In view of the fact that Telefunken quite some time ago discontinued manufacture of the VF 14 tube used in the U 47 and U 48 microphones, Neumann has devised a means of converting these microphones from the VF 14 tube to another tube. Due to the fact that no completely equivalent tube is available on today's market, the following changes have to be made:

NG power supply schematic:

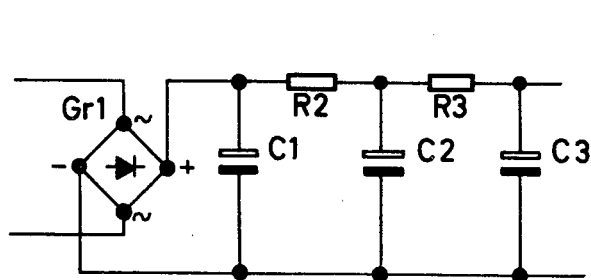
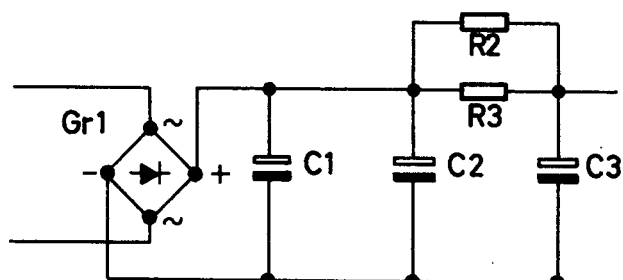
The NG pwr supply must have a small change of wiring due to the greater heater current required by the nuvistor.

- a) Replace resistor R-2 (1 k Ω power resistor coming from + terminal of rectifier) by a solid wire connection between the first two electrolytic capacitors.
- b) Install this same R-2 in parallel with R-3 (an identical resistor next in the RC filter chain), thereby making its total resistance value 500 Ω .
